## VILLAGE OF HOFFMAN ESTATES PLANNING AND ZONING COMMISSION STAFF REPORT

**PROJECT NUMBER:** 2021-015P  
**PROJECT NAME:** Stonegate Conference and Banquet Centre  
**ADDRESS/LOCATION:** 2401 W. Higgins Rd.  
**PROPERTY SIZE:** ~8 acres  
**OWNER / PETITIONER:** NWSMG Management, LLC / Syed Mustafa Ali  
**REQUEST:** Site Plan Amendment and Special Use for a banquet facility  
**PUBLIC HEARING:** Yes  
**ZONING / LAND USE:** B-2 Community Business District / vacant conference center  
**ADJACENT PROPERTIES:** NORTH: B-2, Barrington Square Animal Clinic and Shopping Center  
SOUTH: RPD, St. Alexius Medical Center  
EAST: RPD, Vacant  
WEST: B-2, Moretti's/Restaurant Mall Subdivision  
**PZC MEETING DATE:** September 15, 2021  
**STAFF ASSIGNED:** Kevin Anderson, Associate Planner

**Request for a Site Plan Amendment and Special Use for the Stonegate Conference and Banquet Centre property located at 2401 W. Higgins Road.**

Issue Date: 08/10/2017  
 Scale: 1/32" = 1'-0"  
 Sheet: ARCHITECTURAL SITE PLAN  
**A1.0**  
 PAI PROJECT NUMBER: 21135.00

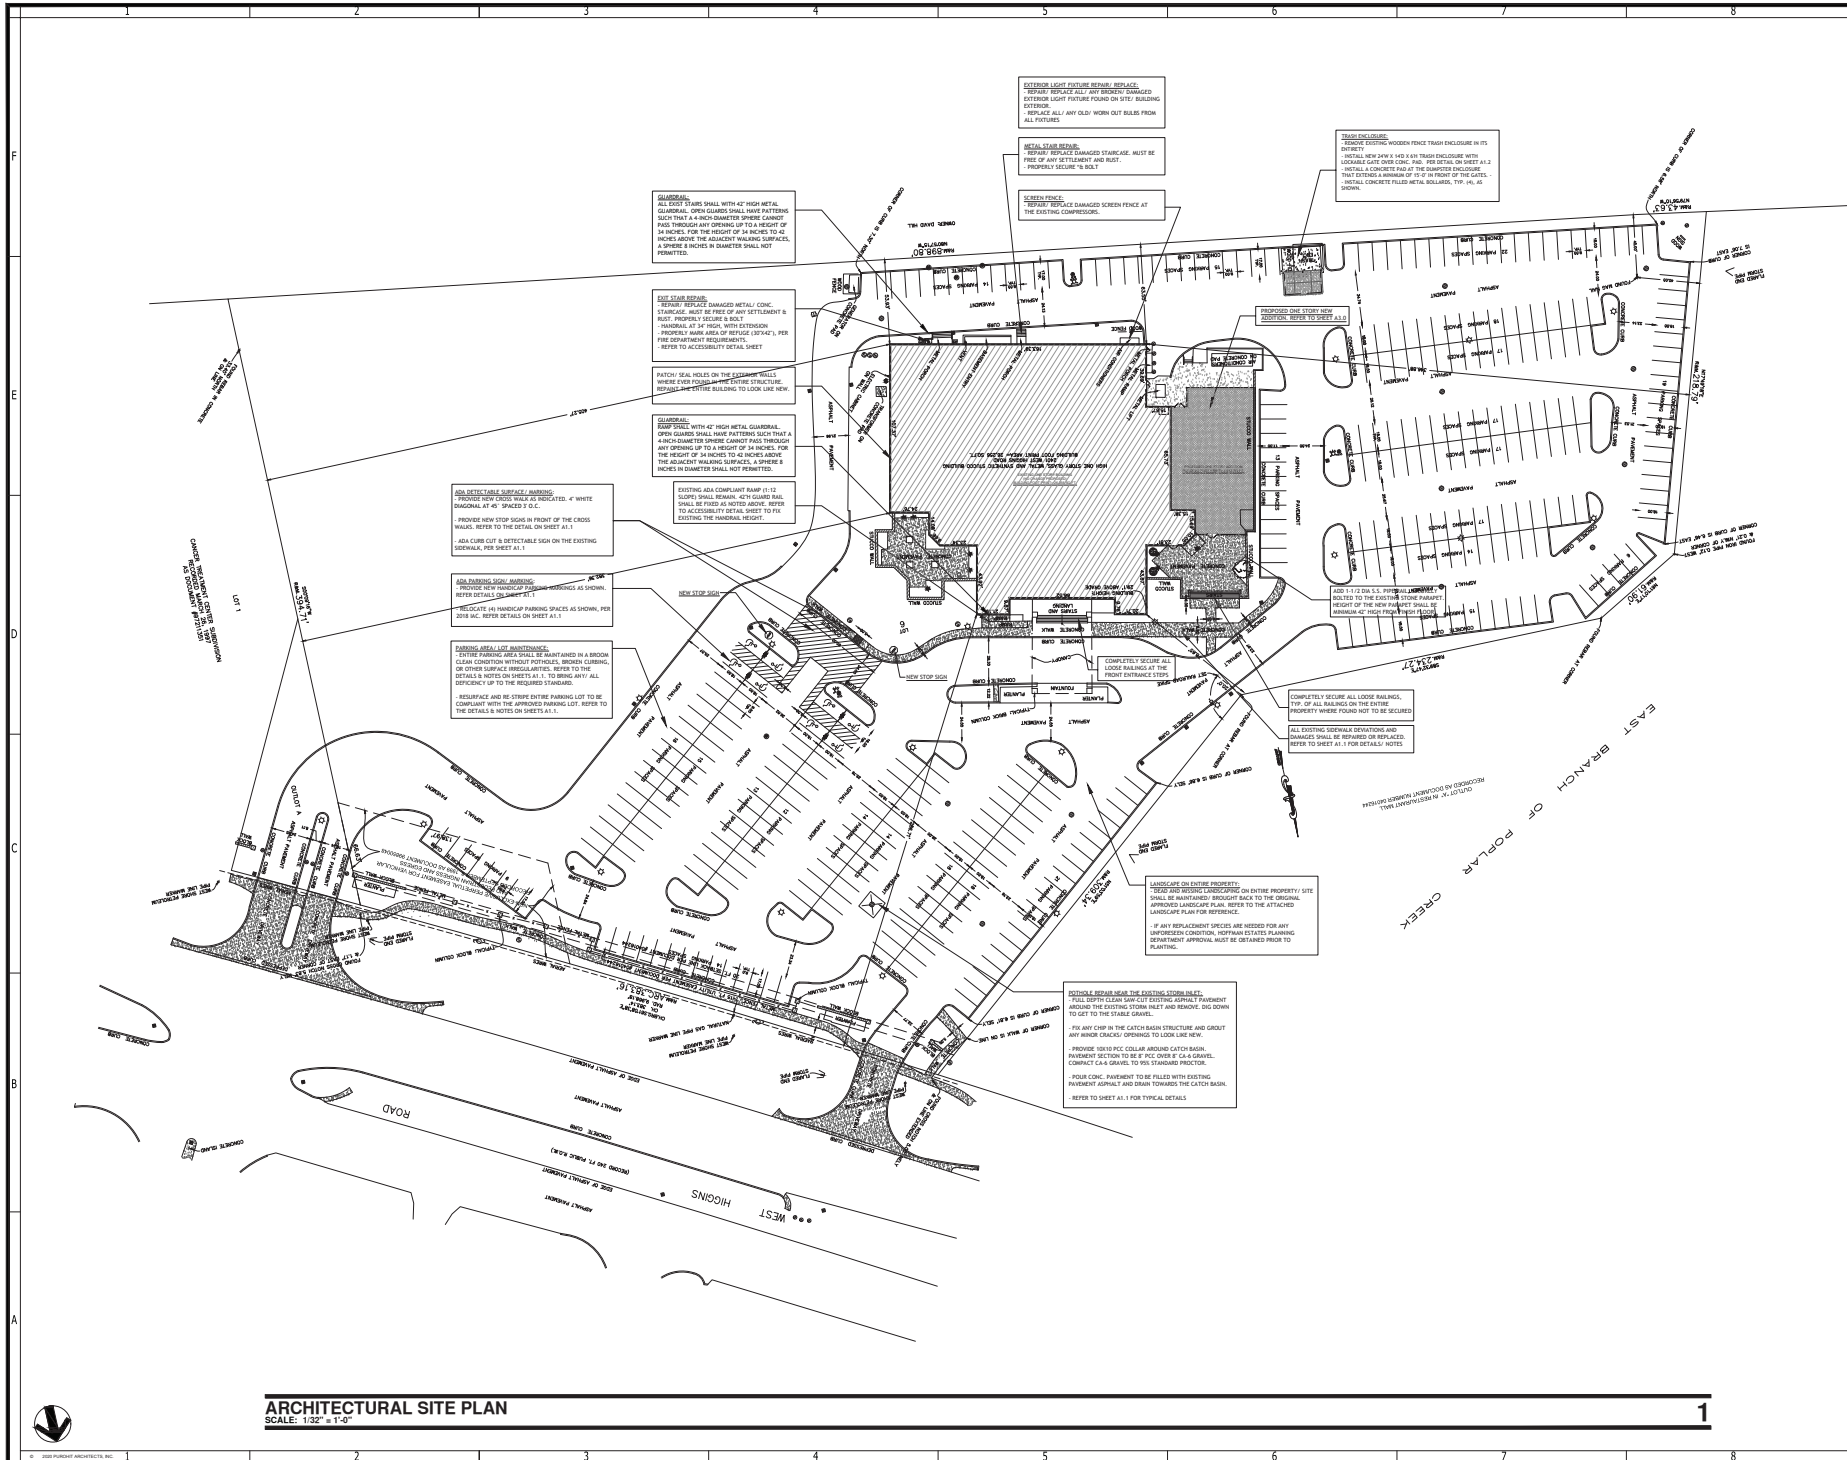
Comment #5:

- a: Refer to the revised site plan & details
- b: Refer to revised sheet A1.0 & A1.0a for all missing dimensions
- c: Refer to revised sheets A1.0 thru A1.2

Issue Date: 08/10/2017  
 Drawn by: PJA  
 Sheet: 1ST FLOOR PLAN PROPOSED ADDITION  
**A3.1**  
 PAI PROJECT NUMBER 21135.00

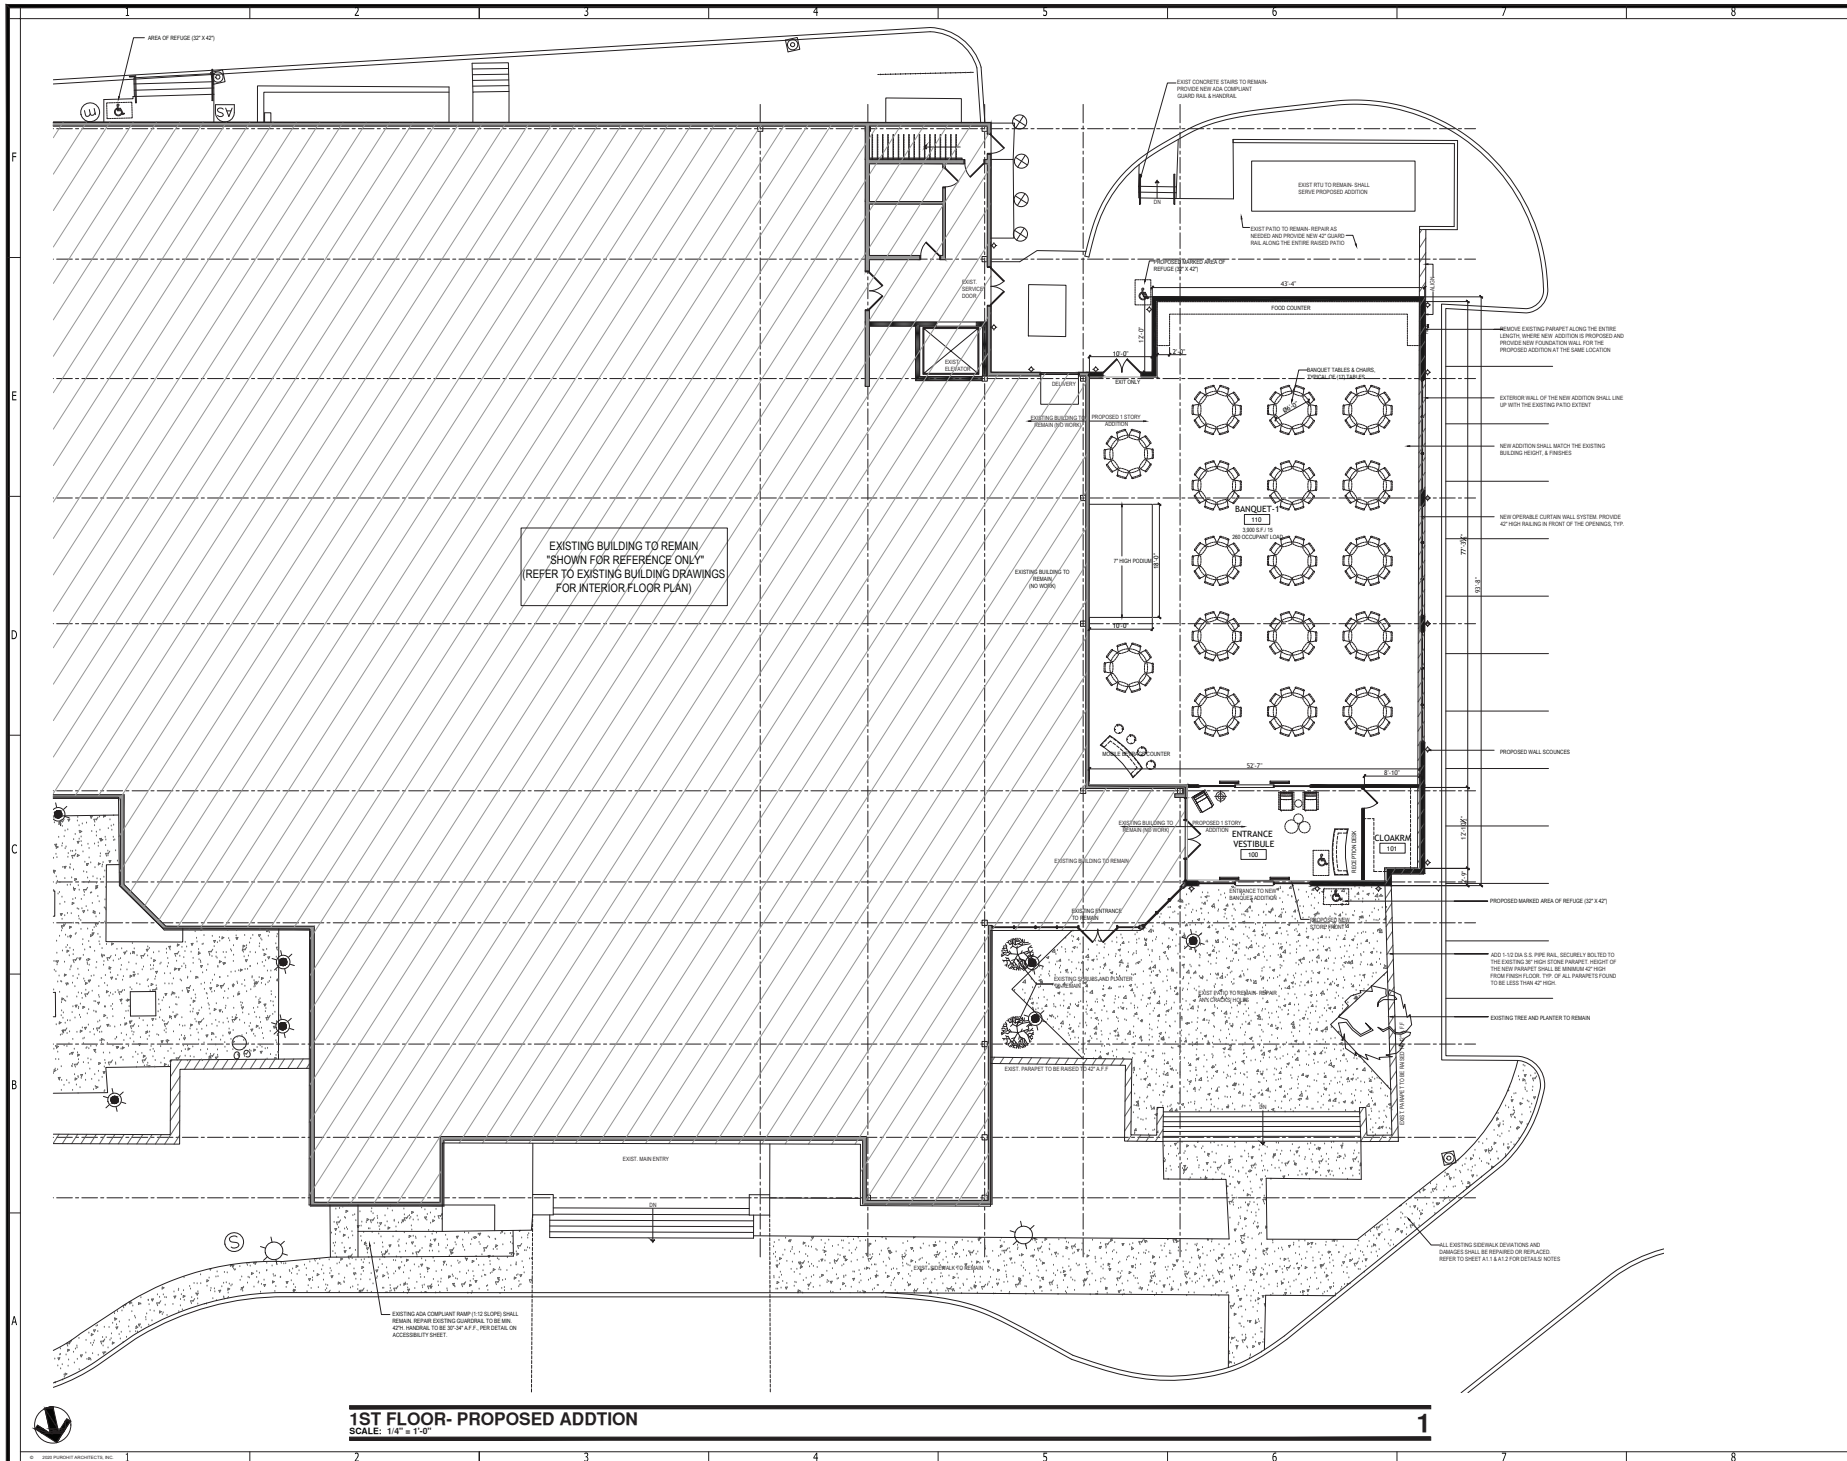
Comment #6:

The ownership would like to propose a new permanent structure at the west patio, where the Patio once had a tent structure. New Proposed building footprint shall be 4,612 Sq. Ft. Please, refer to the conceptual floor plan, exterior elevations & code Matrix provided.

- a: Refer to the code Matrix on added sheet T1.0
- b: A Licensed Structural engineering services has been retained to evaluate the patio structural analysis for its feasibility. Licensed Structural Engineer's drawings/ calculations shall be submitted when applying for Building Permit for the proposed addition.
- c: Required number of exists per code shall be provided for the proposed addition. The existing ADA Compliant Ramp at the main building entry shall serve the entire facility including the addition. Area of Refuge, outside any other exit doors as required by the Building Code/ Fire Department shall be provided/ address when applying of the building permit.
